**PLANNED UNIT DEVELOPMENT
STAFF REPORT****Date: December 1, 2011****DEVELOPMENT NAME**

Christ United Methodist Church

CONTEMPLATED USEPlanned Unit Development Approval to amend a
previously approved Planned Unit Development allowing
multiple buildings on a single building site and cross-access
between building sites to allow construction of a new ball
field and a new picnic pavilion.**TIME SCHEDULE
FOR DEVELOPMENT**

SITE PLAN

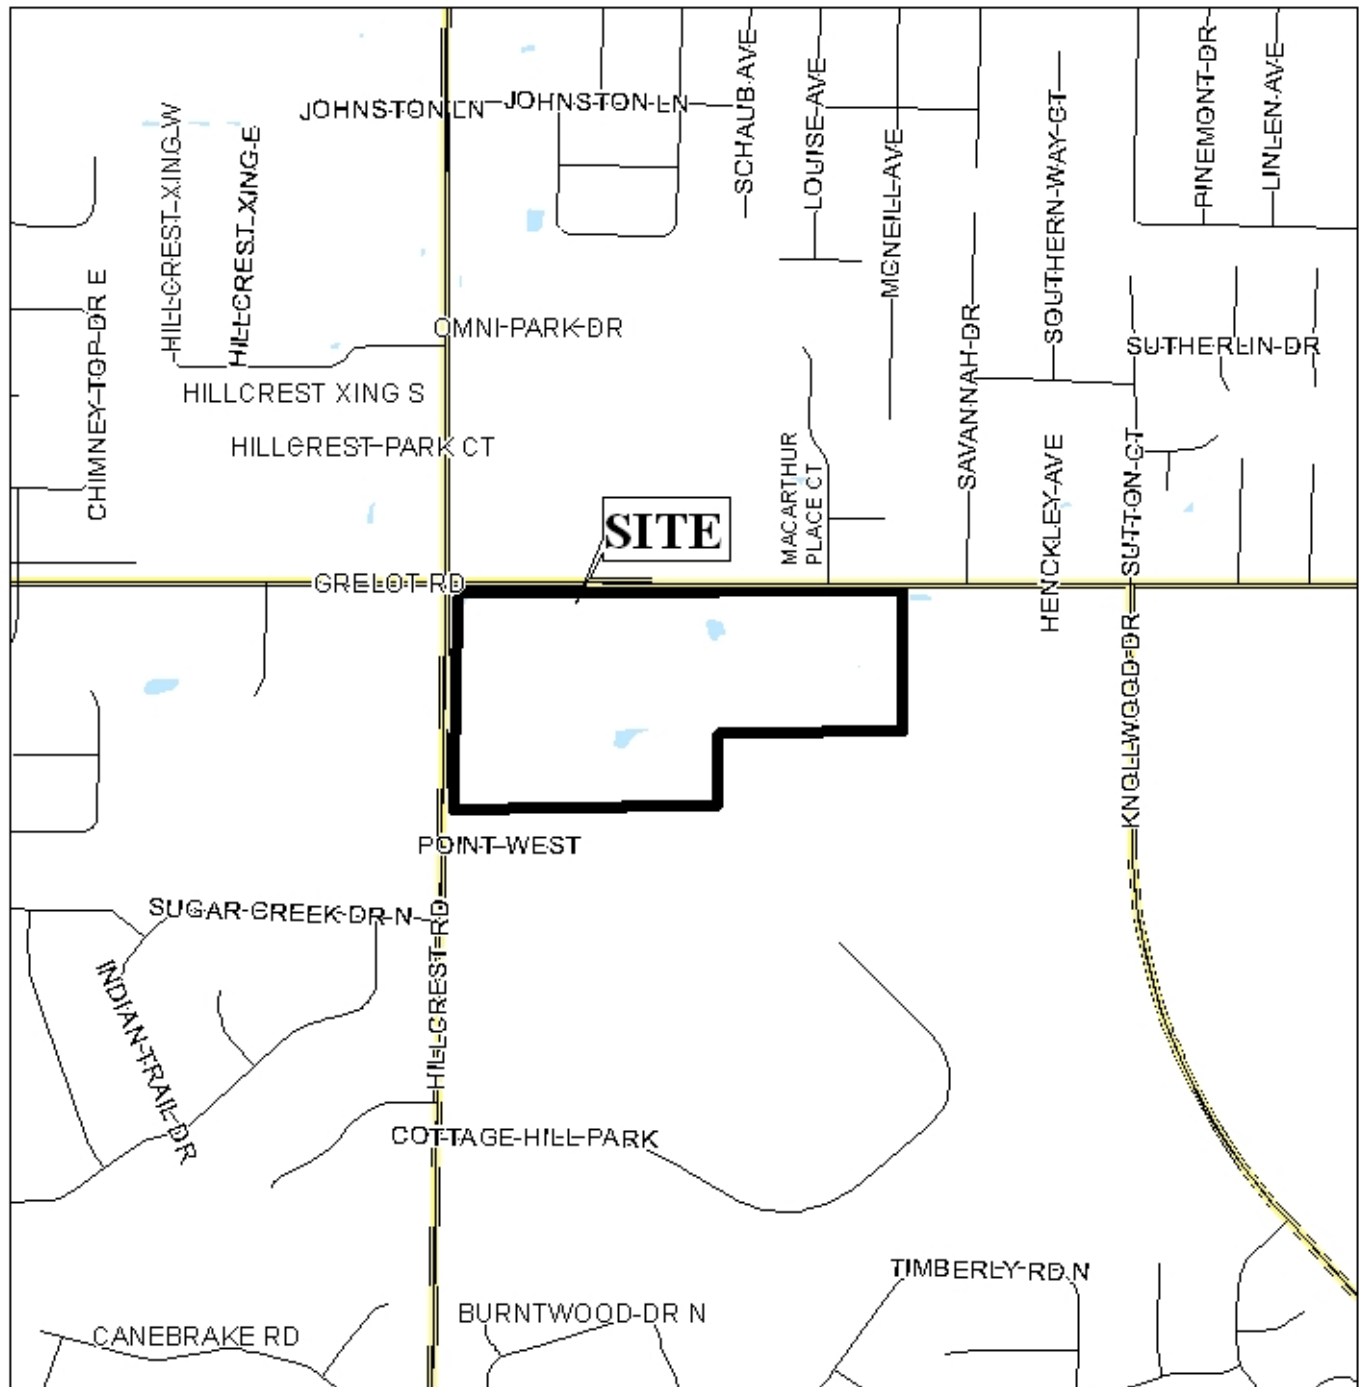
The proposed ball field will be located Northeast of what appear to existing ball fields, next to an existing parking lot. There is no information indicating who will use the ball field, the hours of use, if the field will be illuminated, if there will be bleachers, or if there will be other improvements other than a fence. The 60 x 60 foot picnic pavilion will be adjacent to the apparent existing ball fields, abutting an existing parking lot. As with the proposed ball field, no information is provided regarding the use of the pavilion, such as the hours of operation or the range of potential users: the structure will be approximately 180 feet north of an existing apartment complex, thus noise and lighting may be issues of concern.

It should be noted that the submitted site plan does not depict what appear to be existing ball fields, bleachers, fencing, and it appears to under-represent the size of the existing storage building that abuts Medal of Honor Park – the plan shows it as 25 x 50 feet in size, while measurements of aerial photos in the GIS system indicate that the building is 25 x 75 feet in size. The GIS aeriels also indicate erosion and surface wear in unpaved areas of the site, which imply that parking and vehicle access is occurring on unpaved areas: parking must occur on paved areas, or a variance must be obtained to allow parking on unpaved or marginally improved surfaces.

Finally, the proposed ball field and picnic pavilion uses may have to comply with accessibility requirements of the Americans with Disabilities Act, thus ADA-compliant parking, access routes, etc, may be required. The design professional should verify ADA-related site design requirements, if any, and revise the submitted site plan to reflect any improvements, as PUD approval is site plan specific.

- 1) Revision of the site plan to accurately depict all structures and fields on site, including storage buildings, ball fields, fencing and bleachers; and
- 2) Provision of information regarding any proposed users, hours of operation, night-time use or lighting of the new facilities;
- 3) Revision of the site plan to show any new impervious areas associated with the proposed new facilities;
- 4) Verification of any Americans with Disabilities Act-related site improvements required as part of the proposed ball field and pavilion, if any, and revision of the site plan to reflect those requirements; and
- 5) Delineation of any unpaved areas where parking is occurring for any reason.
